Subject: Sketch Plan Review, 4412 Morningside Road and 4232 Oakdale Avenue

Provide non-binding comments regarding the proposed Sketch Alternatives for the subdivision of this property.

PLANNING COMMISSION STAFF REPORT

| Originator Cary Teague Director of Planning | Meeting Date December 12, 2012 | Agenda # VI.D. File # 2012.014.12a |

Sketch Plan A

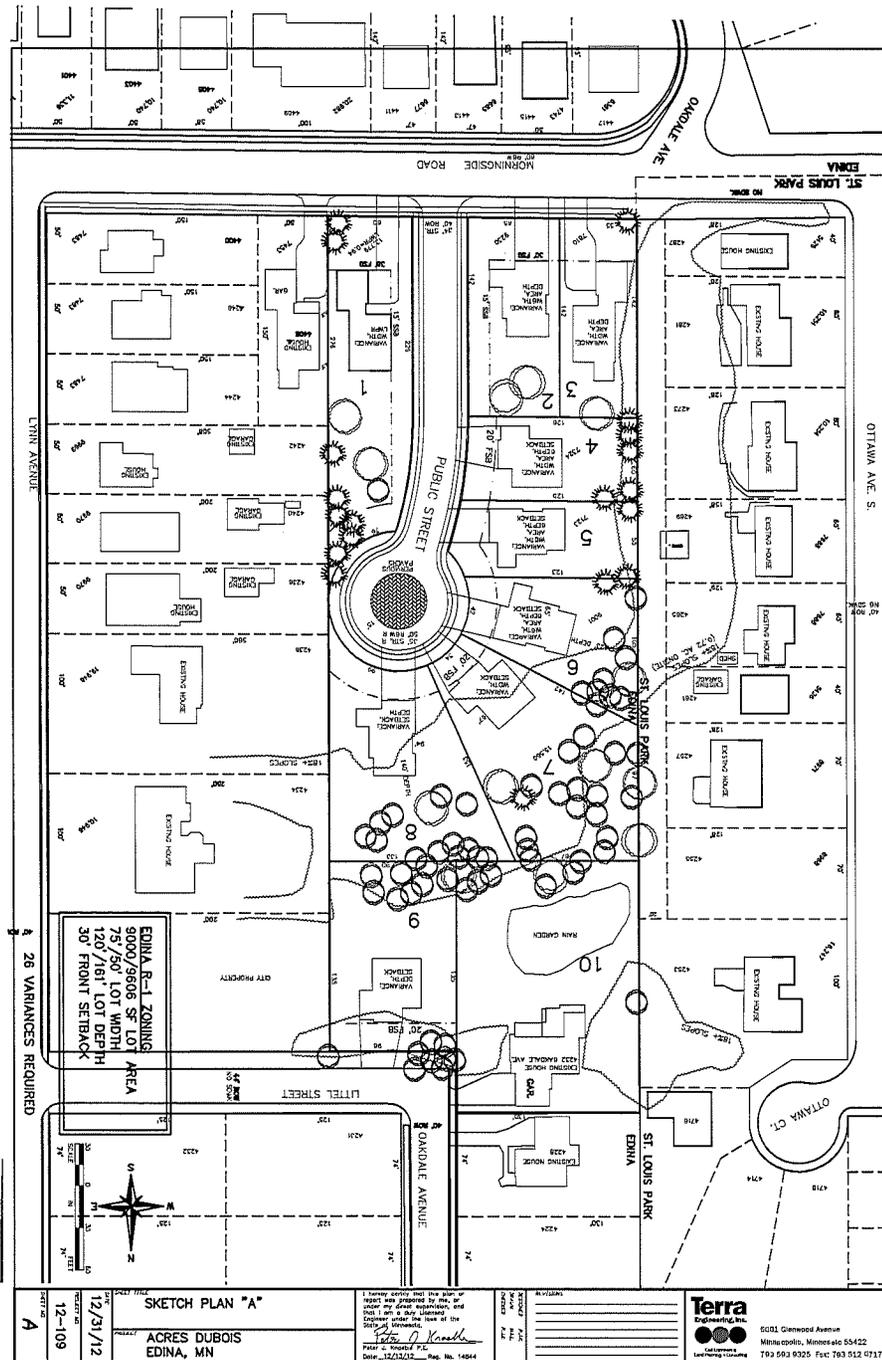
Sidells said in his opinion 50-foot wide lots do not provide enough flexibility for house placement. He added if this concept is favored that the family would need a legal statement from the City guaranteeing that the variances will be available when the houses are built.

Commissioner Fischer said he supports Sketch Plan concept "A". Fischer said in his opinion it's not about the number of lots it's about the street itself. Fischer said whichever concept is ultimately chosen what he wants to see is the creation of a special place and special street. Concluding Fischer suggested that the applicant speak more with the Fire Department to see if they would "come on board" supporting a less wide street (18-feet).

Sketch Plan B

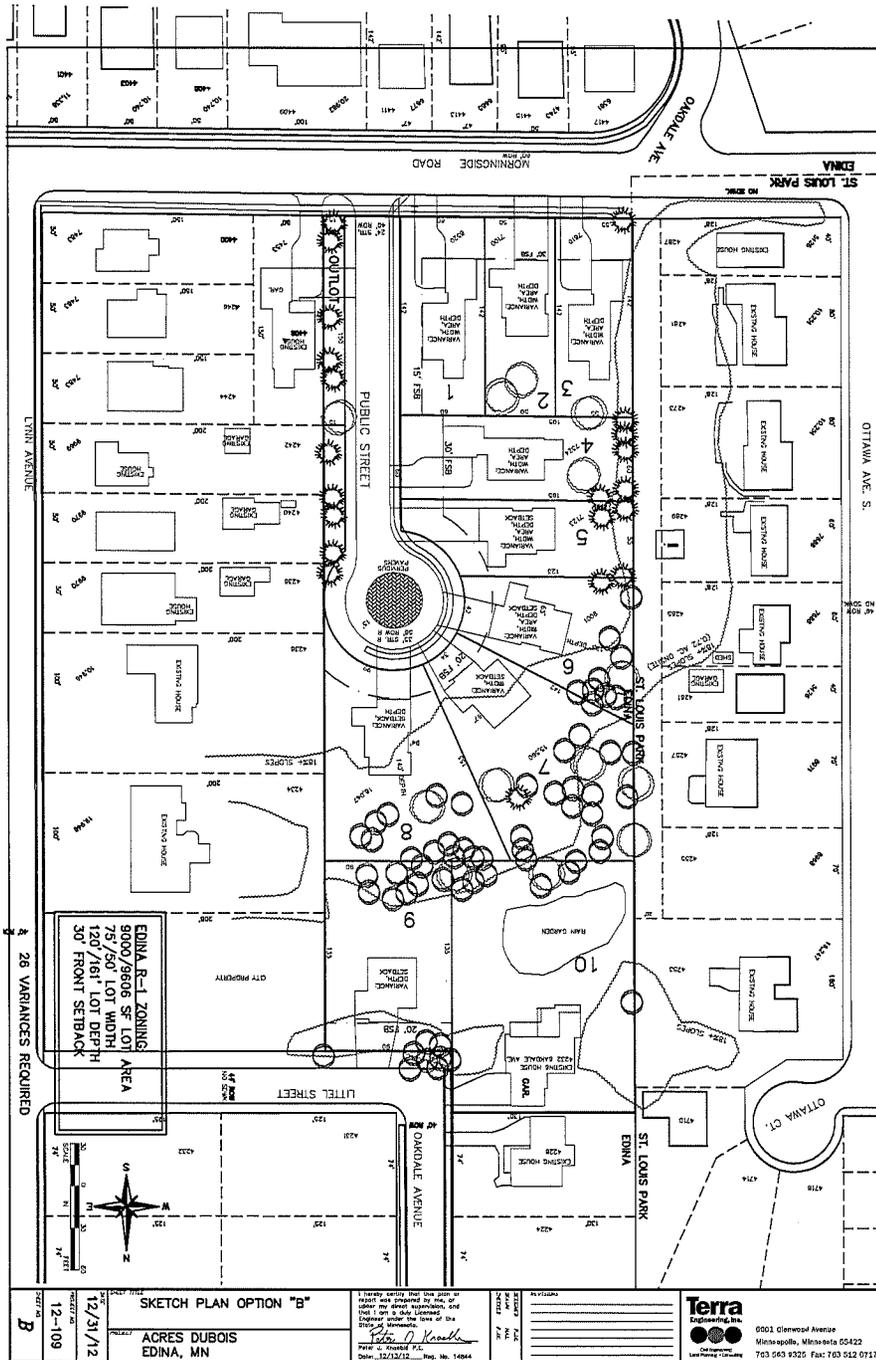
Commissioner Schroeder said with regard to sketch plan concepts A & B that in his opinion the lots fronting Morningside Road would appear disconnected from the rest of this development. Schroeder said that whatever is decided this development should be developed as "its own thing". Schroeder added in his opinion this development should become its own unique and different "neighborhood", part of the Morningside area of Edina. Continuing, Schroeder said the "new" street should be developed as a dynamic living experience. He suggested thinking of the cul-de-sac in a different way; possibility shifting it slightly and play with the geometry of the street creating a "living" fluid street. Schroeder said he's not concerned with lot size; however, wants this street and these houses to become a unique dynamic part of Edina. Concluding, Schroeder said he wants to see a great street developed.

Commissioner Forrest said she was opposed to the through street adding she is also hesitant on supporting the concept of fronting homes on Morningside Road. She said these houses would be isolated from the rest of the development. Continuing, Forrest agreed with Schroeder's suggestion of "playing" with the street. Concluding, Forrest said she would like the Sidells to keep their high redevelopment standards and work closely with developer(s), concluding her preference is the modified original concept.

Commissioner Platteter said he doesn't want this neighborhood to become exclusive adding he continues to believe homes should be fronted on Morningside Road as laid out in Sketch Plan option A & B.

PRELIMINARY GRADING AND EROSION CONTROL PLAN
 ACRES DUBOIS
 EDINA, MN

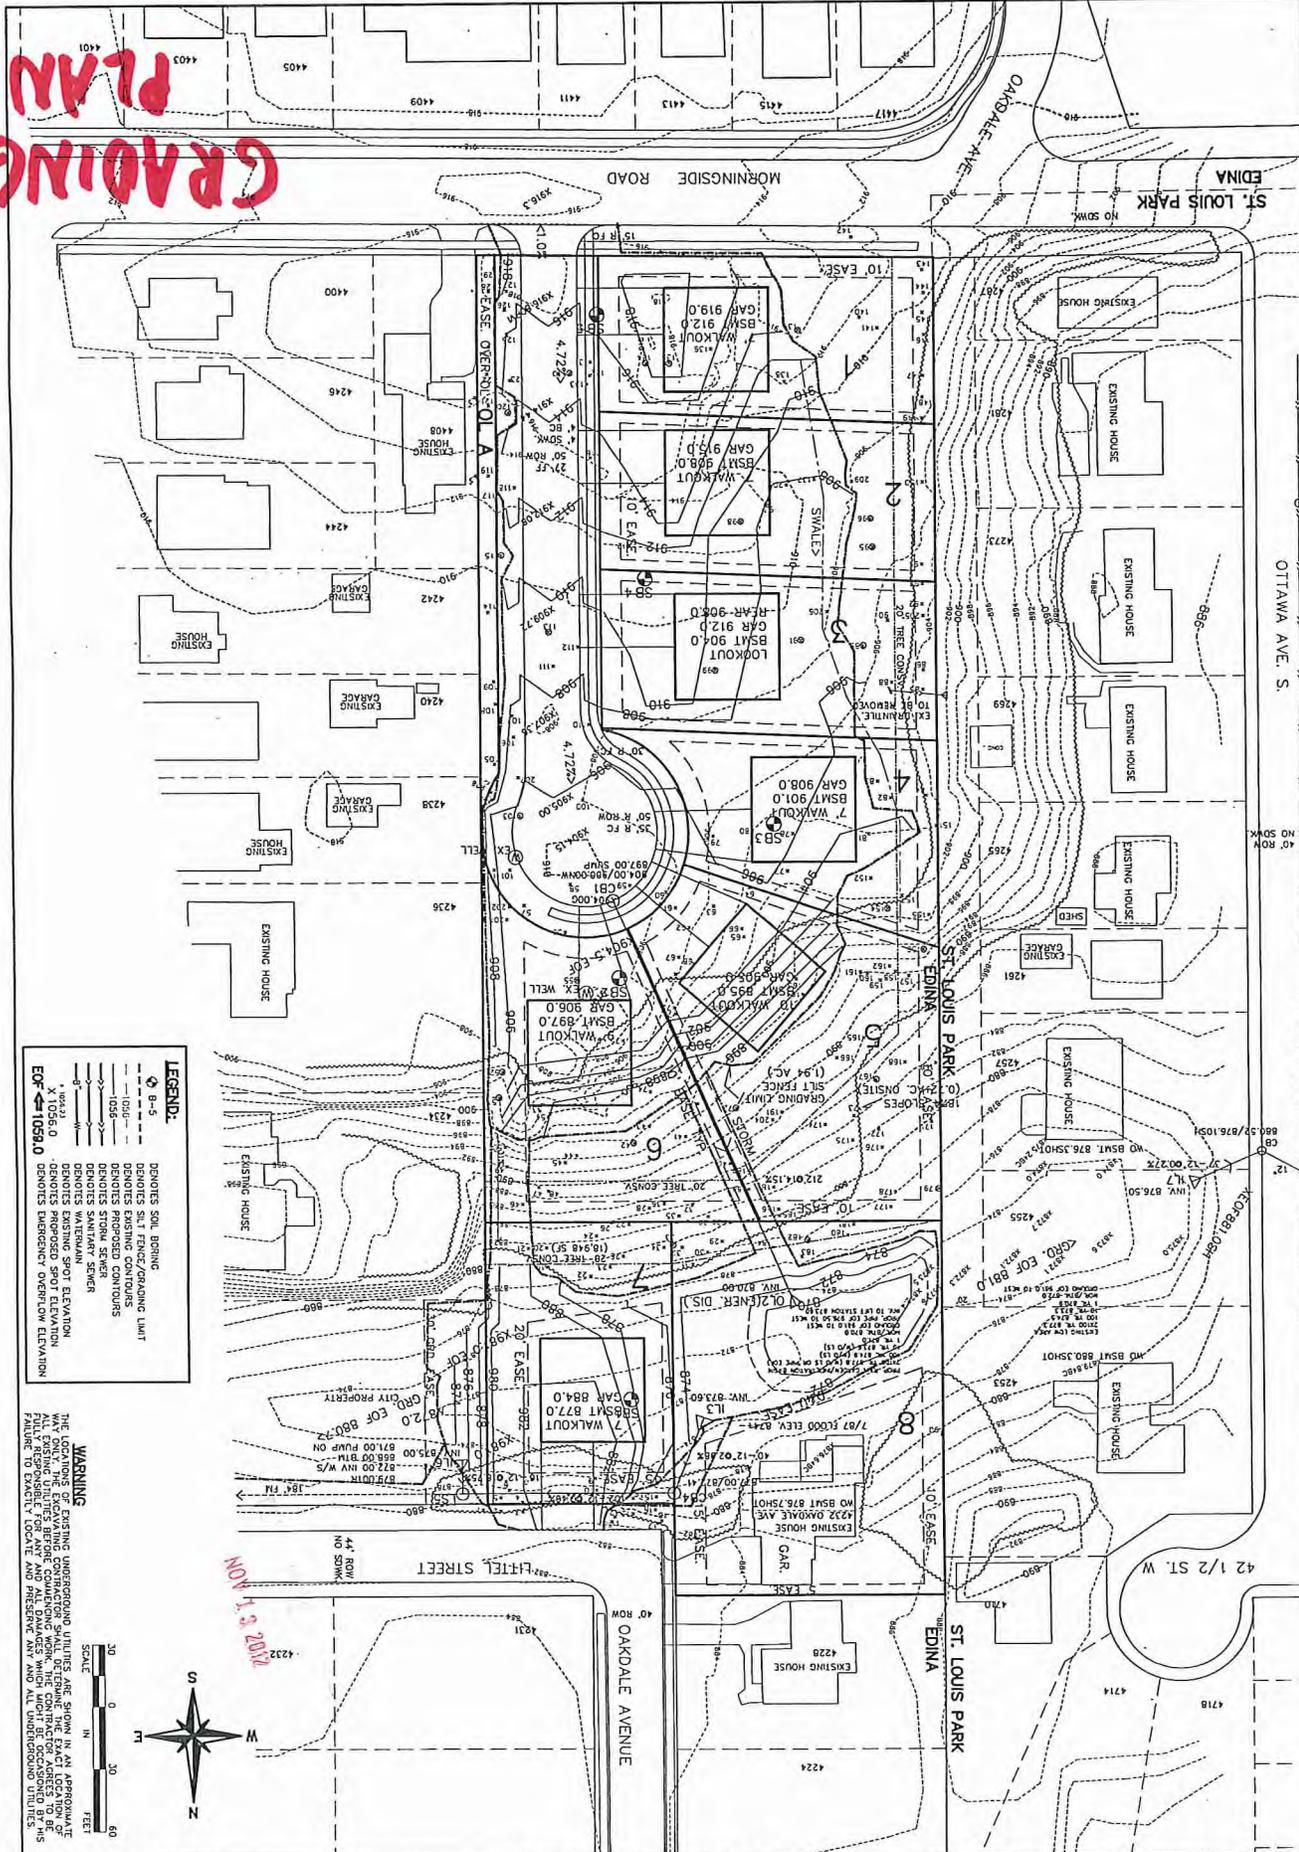
Sheet 5 Preliminary Grading Plan:

- Use of City property adjacent to proposed Lot 7 will require compensation to the City, along with a restoration plan approved by the City Council. Compensation will be calculated as a temporary construction easement. Staff does not support the placement of a retaining wall at this location due to long term maintenance adjacent to proposed sanitary sewer and water main.

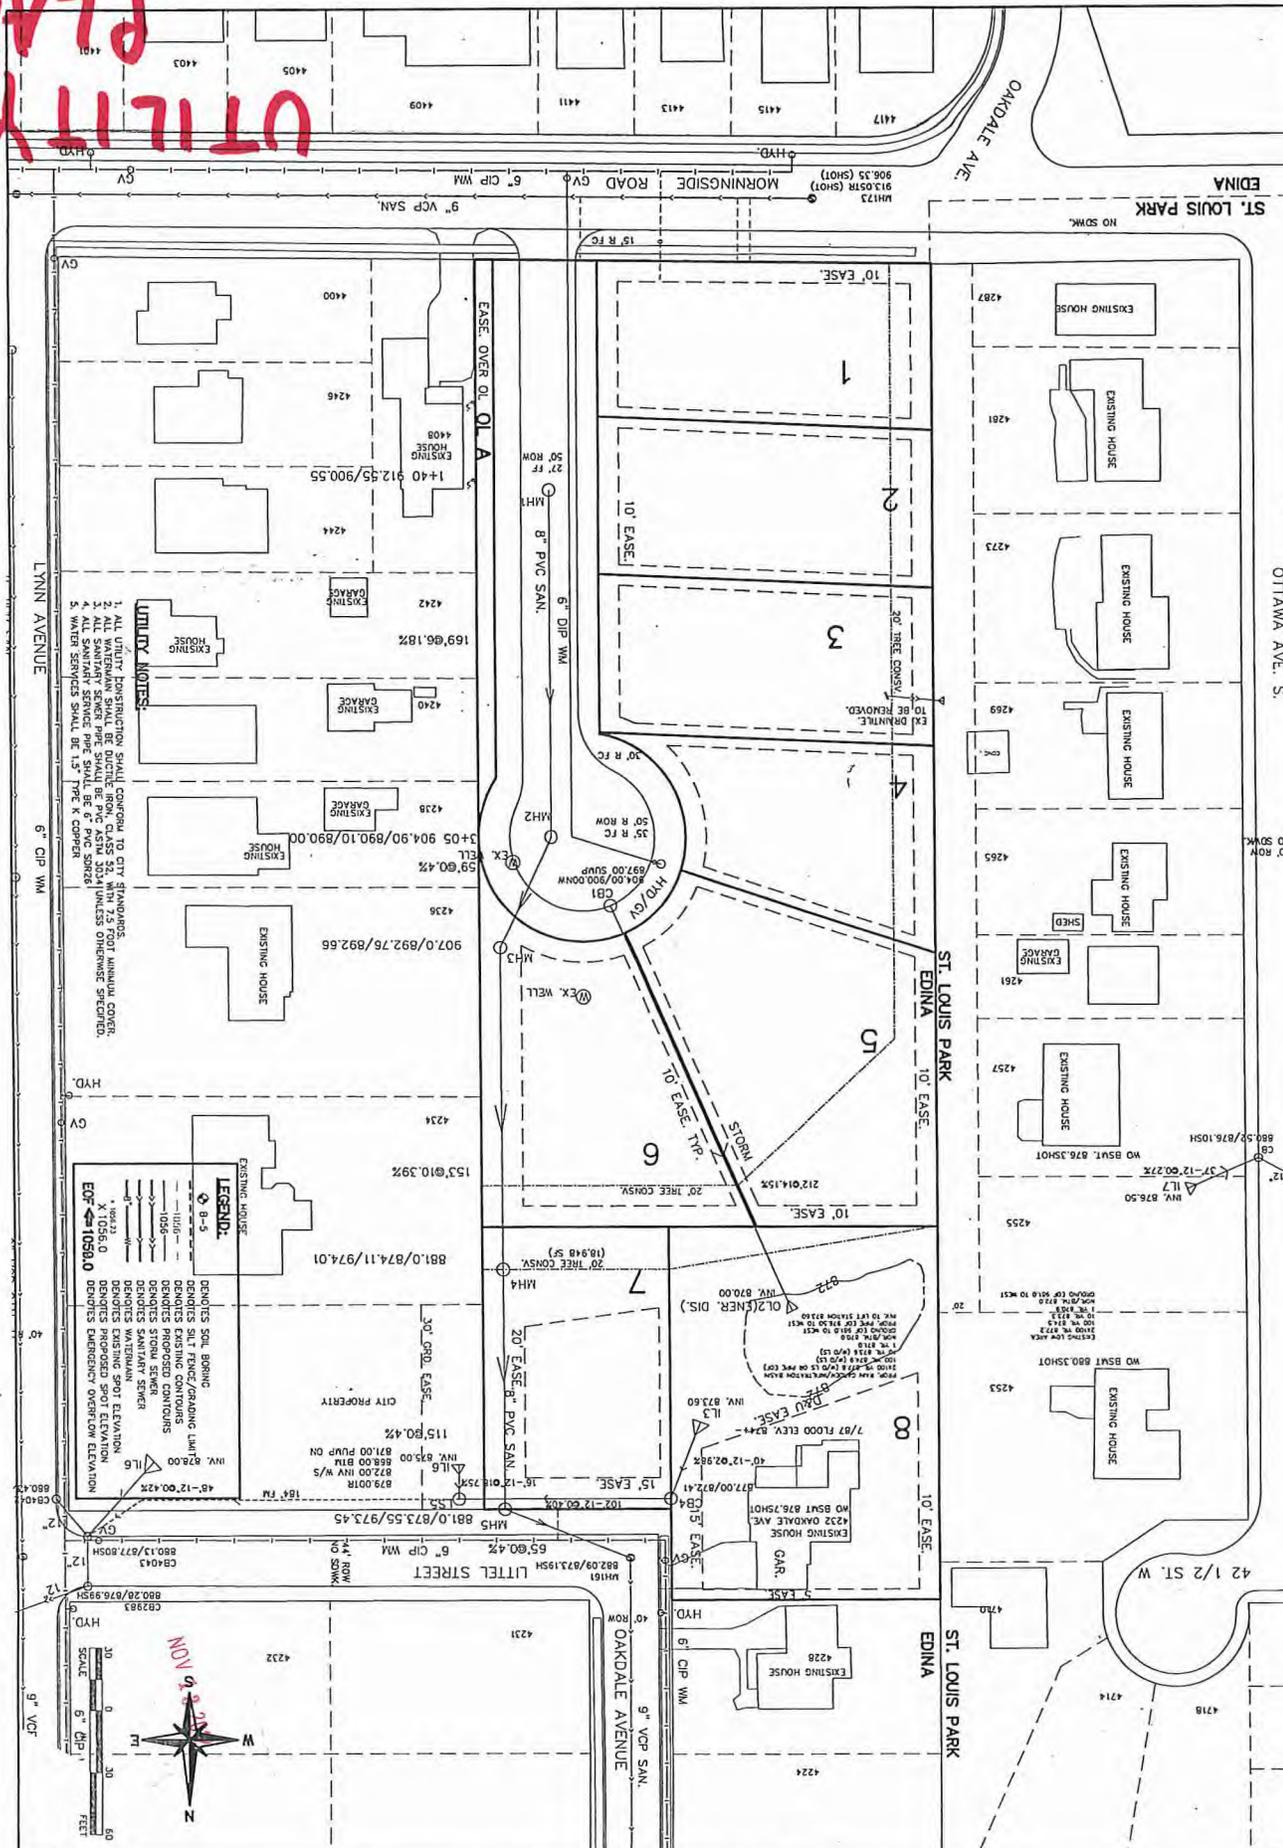
Sheet 4 – Preliminary Utility Plan:

- Loop / connect water main from Morningside Road to Littel Street.
- Provide additional easement for access to maintain proposed rain garden / infiltration basin located at Lot 8.
- Provide storm water calculations for the project. Per the City of Edina's Comprehensive Surface Water Management Plan, verify that the proposed rain garden located at proposed Lot 8 can provide a two foot clearance to surrounding structures by providing storage for a concurrent 100-year single rainfall event or a 100-year 10-day snowmelt, whichever is greater.

PRELIMINARY SITE PLAN
 ACRES DUBOIS
 EDINA, MN

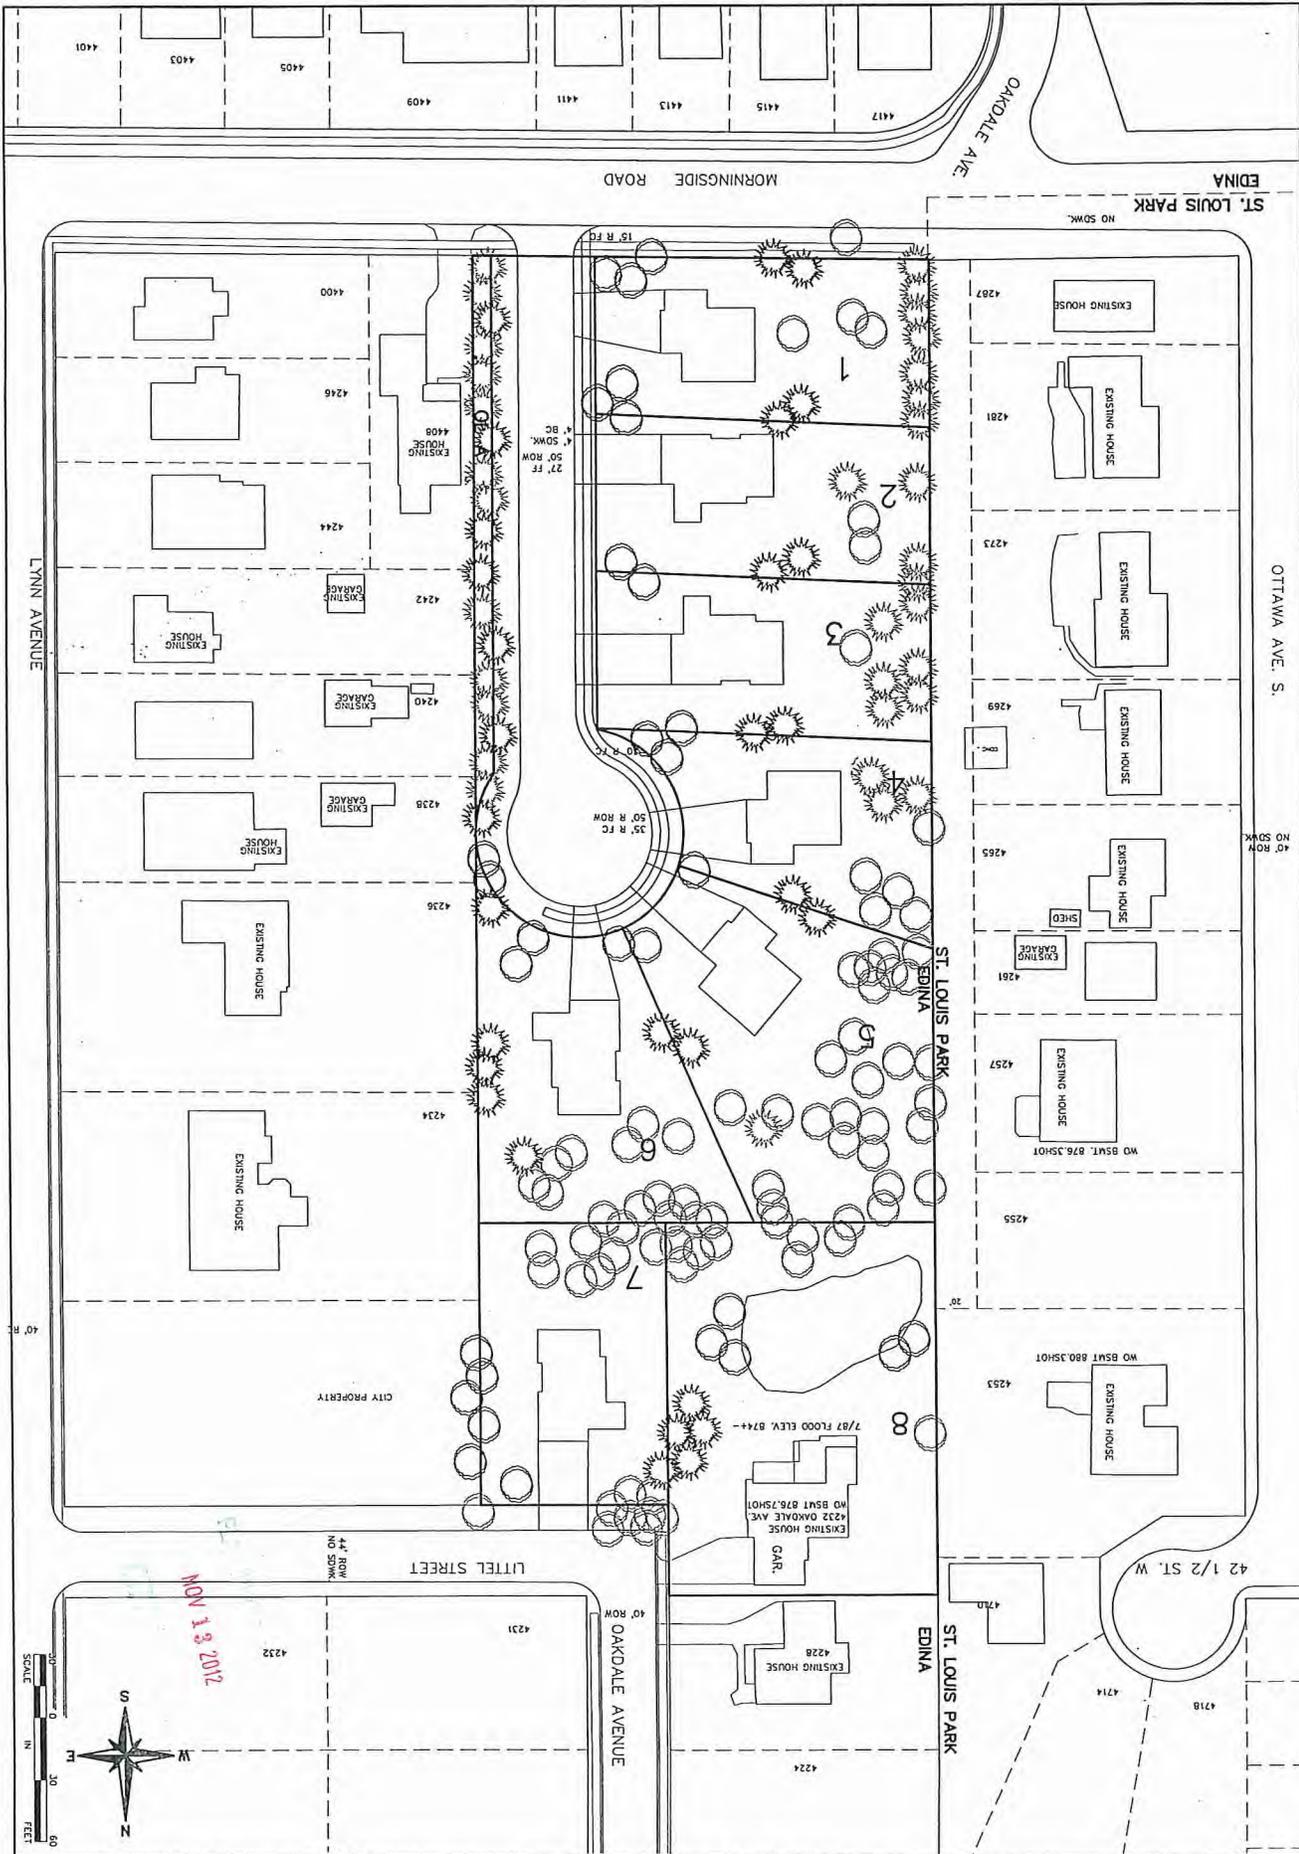
Sheet 3 – Preliminary Site Plan:

- Dedicate Outlot A to adjacent properties to provide maintained boulevards. If the outlot is not dedicated then staff recommends utilizing the area to create bio-swales, which requires the creation of a homeowners association to maintain the bio-swales after the three year maintenance period.
- Provide a minimum of three decorative street lights adjacent to the sidewalk.
